**Ordinance Number: 1365-23, File Number: 19-24**

**RTA Tunnel Membrane Replacement- Addendum 3**

**NARRATIVE:** Addendum 3 contains the following:

Project Title <b>RTA TUNNEL MEMBRANE REPLACEMENT</b>			
Sheet Title <b>MAINTENANCE OF TRAFFIC PHASES 3 AND 4</b>			
Designed: MSI	Drawn: MSI	Checked: LGW	Approved: LGW
Scale: AS SHOWN		Project No.: 198348	
Date: FEBRUARY 2024		Sheet: C-13

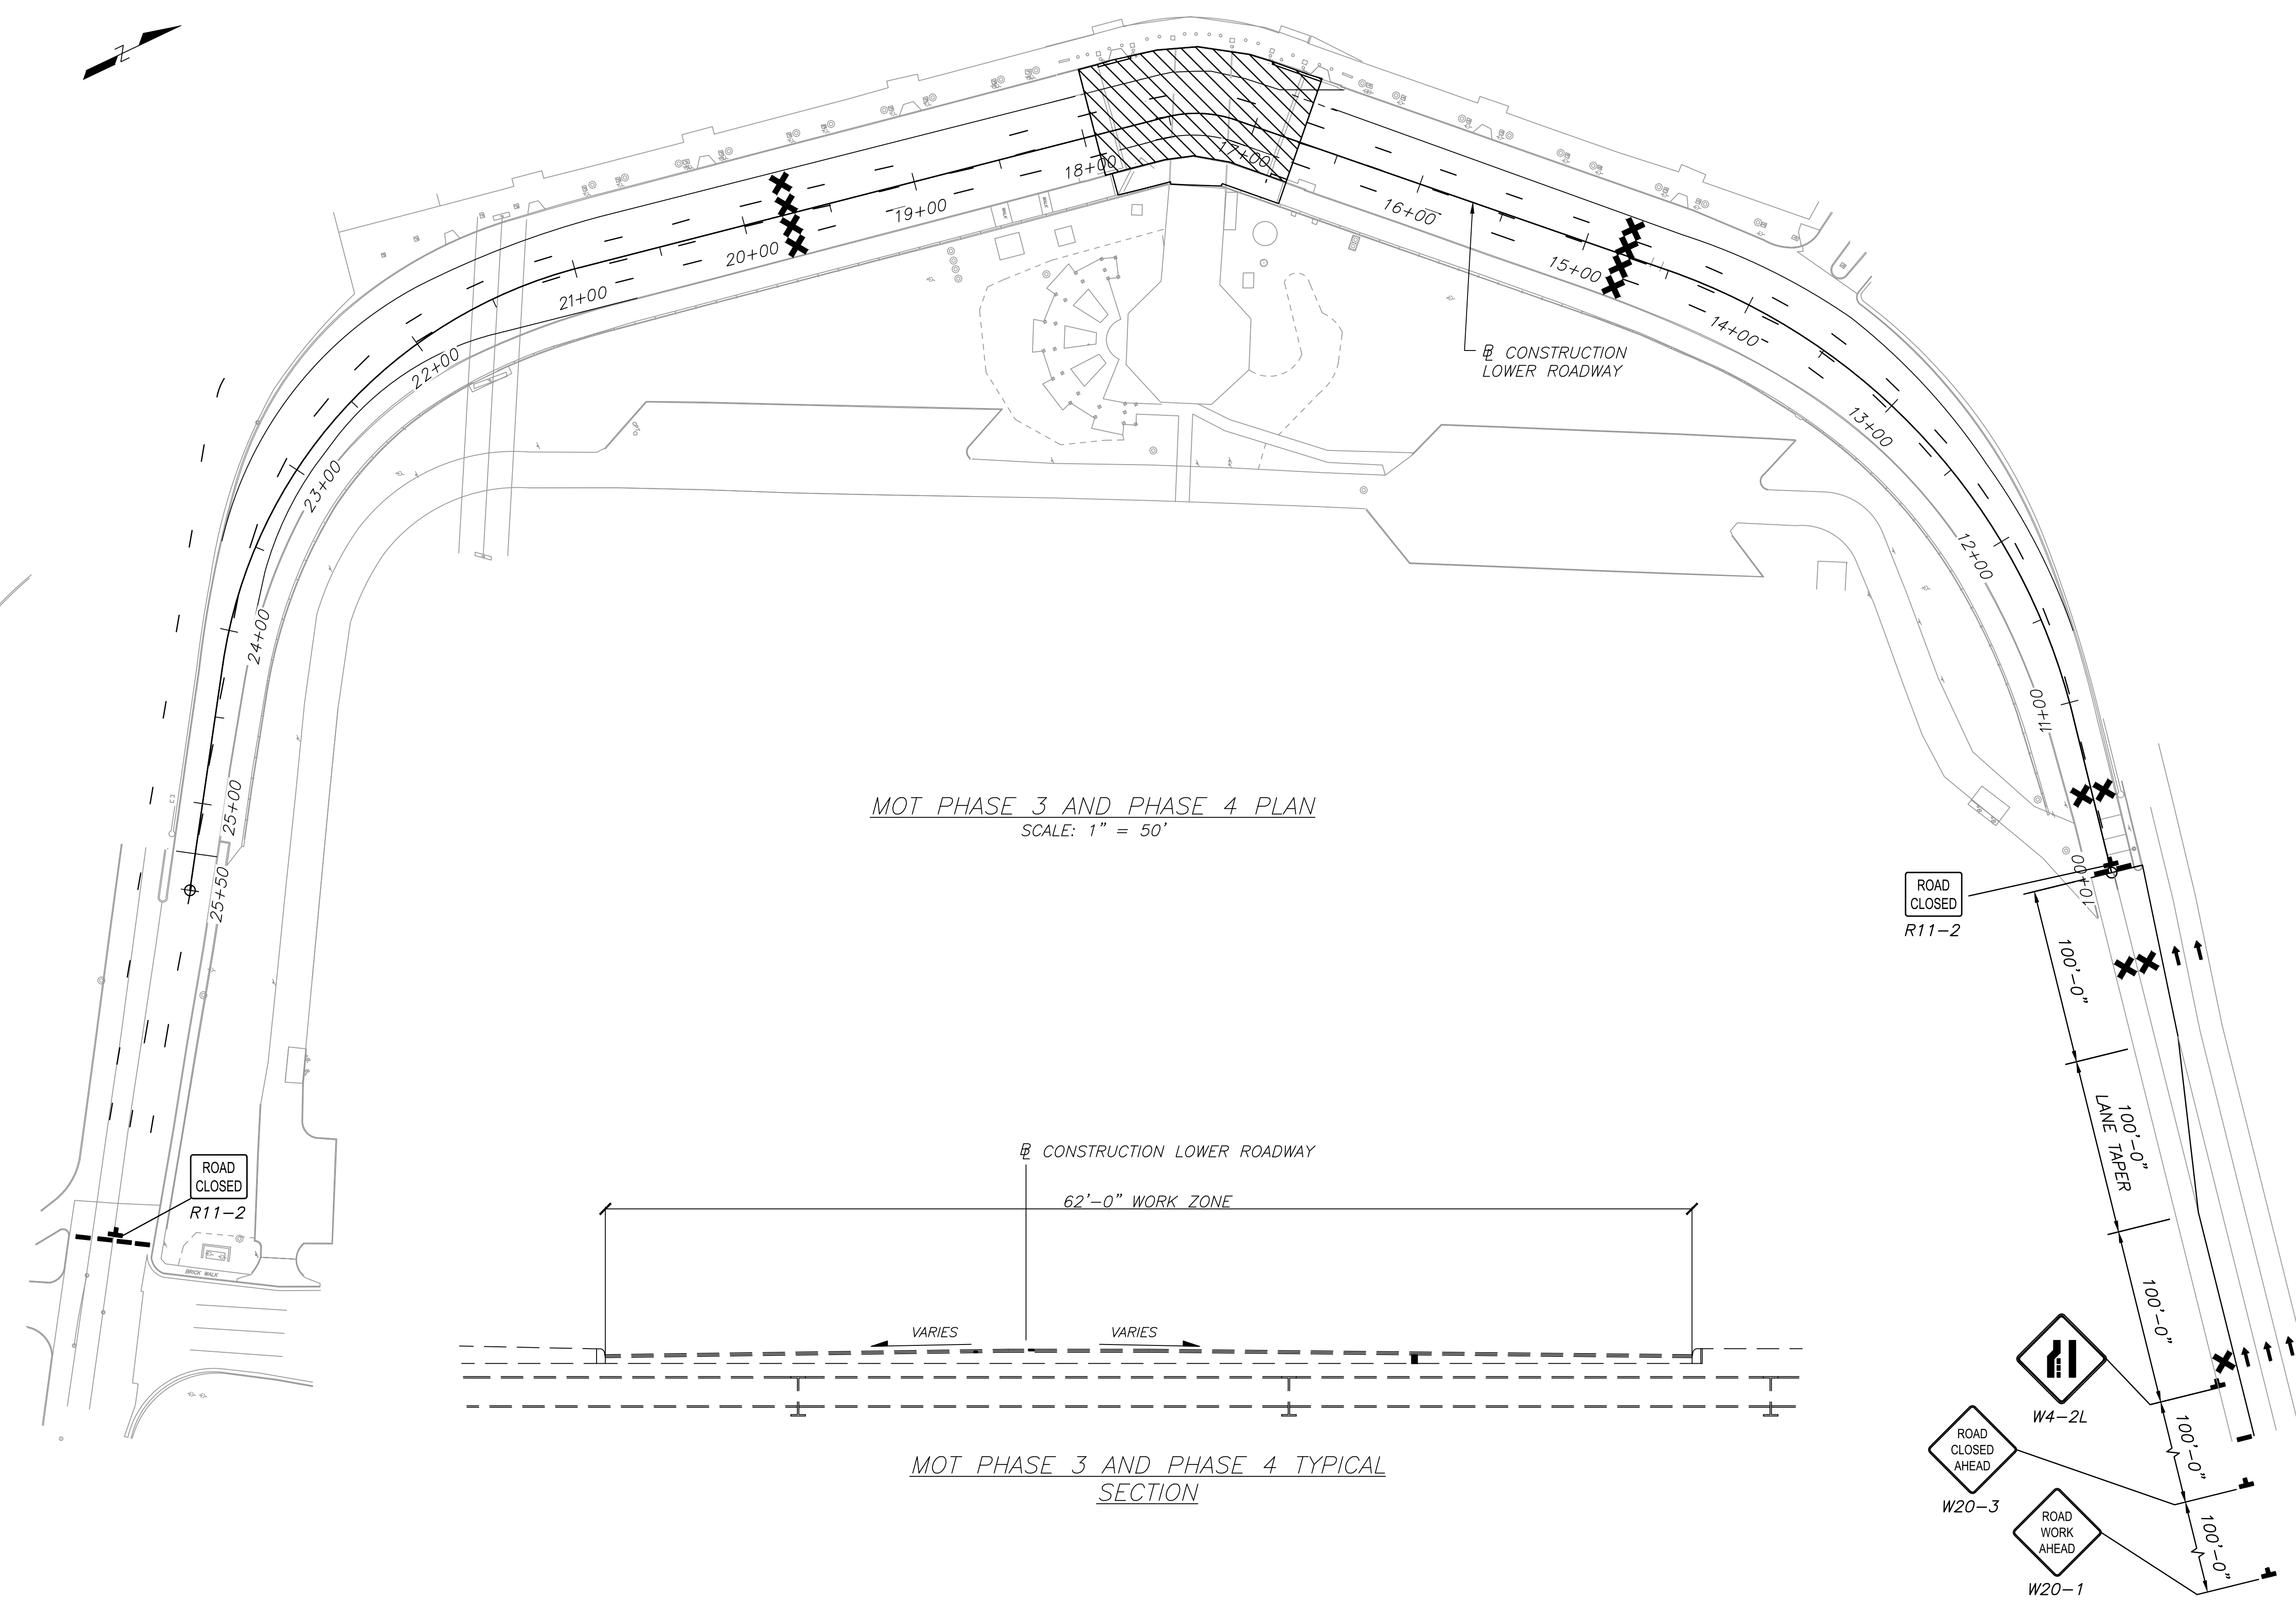
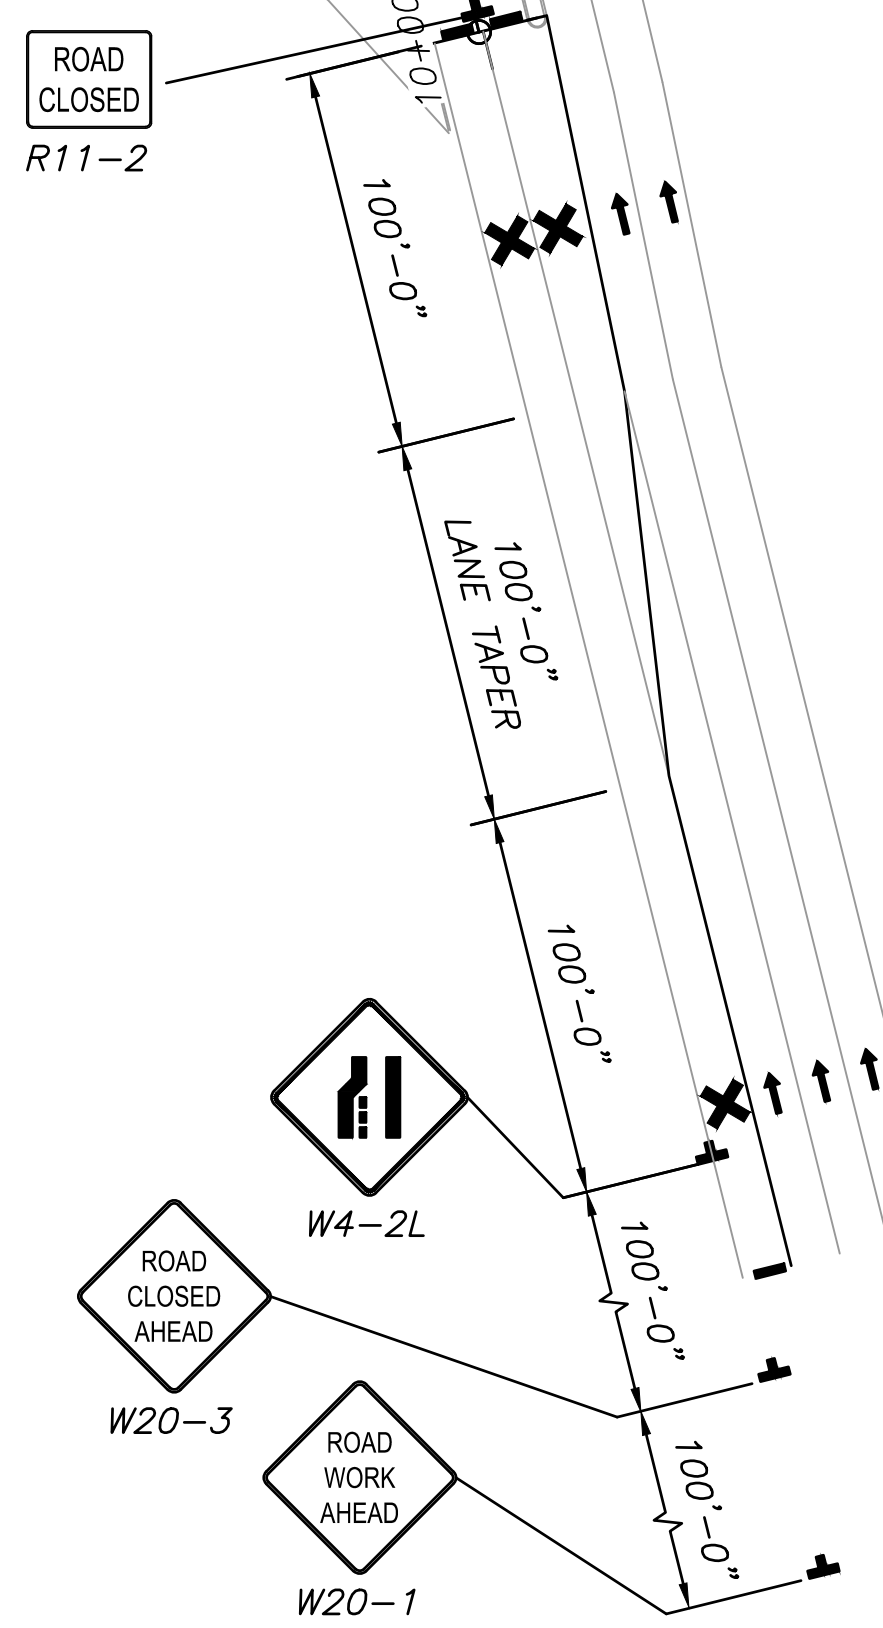
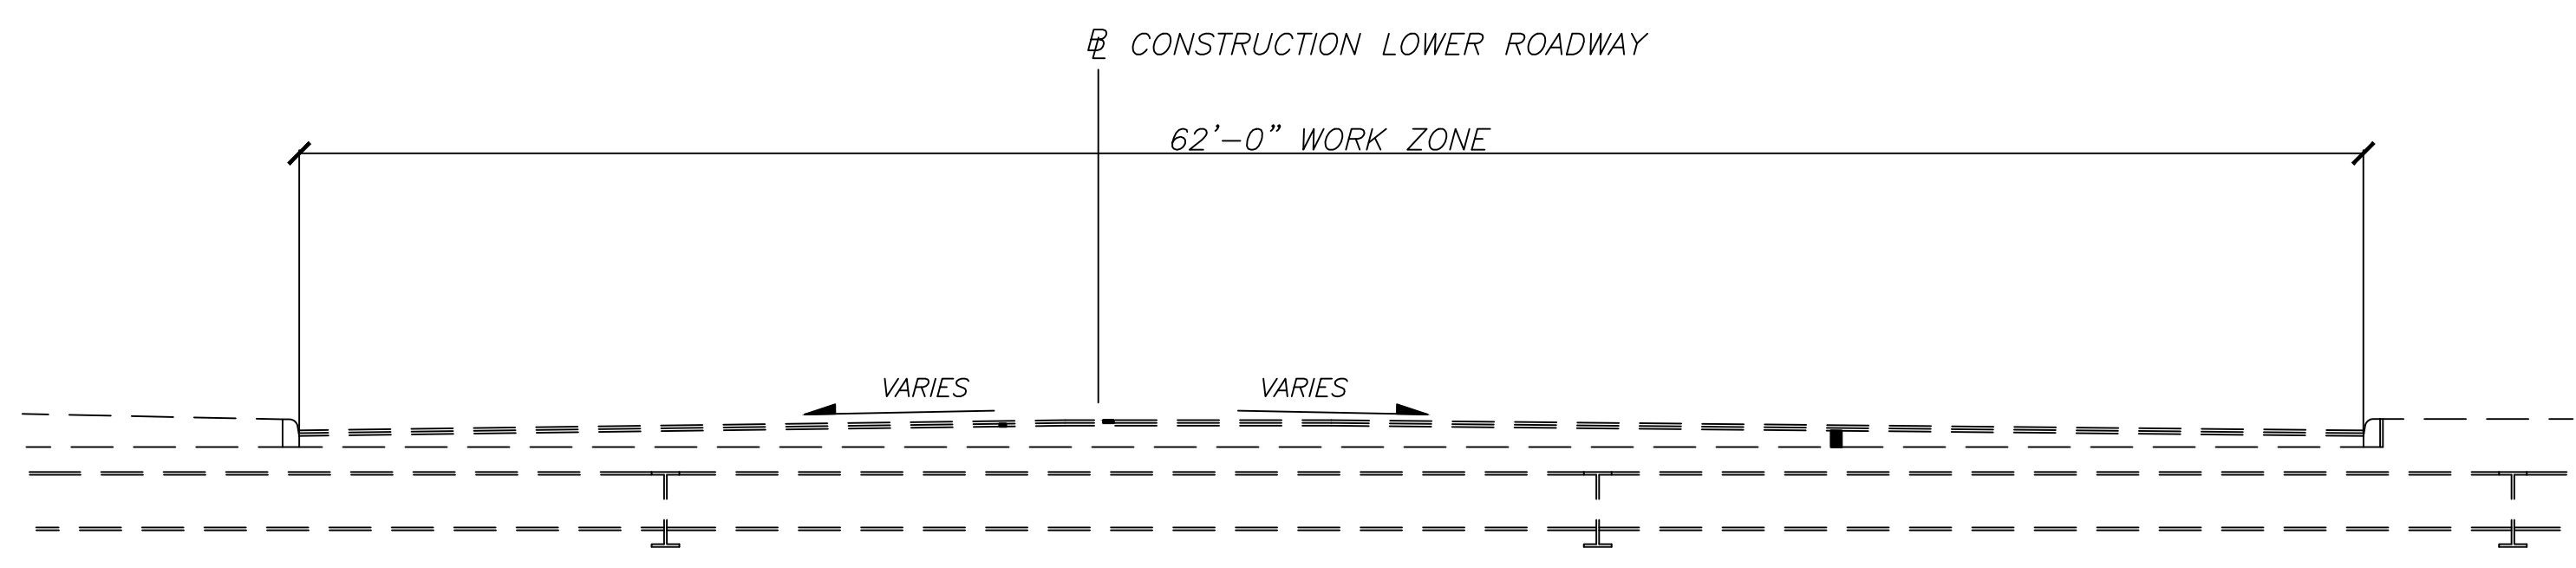
**NOTE: ENTIRE SHEET REVISED FOR ADDENDUM A-3.**
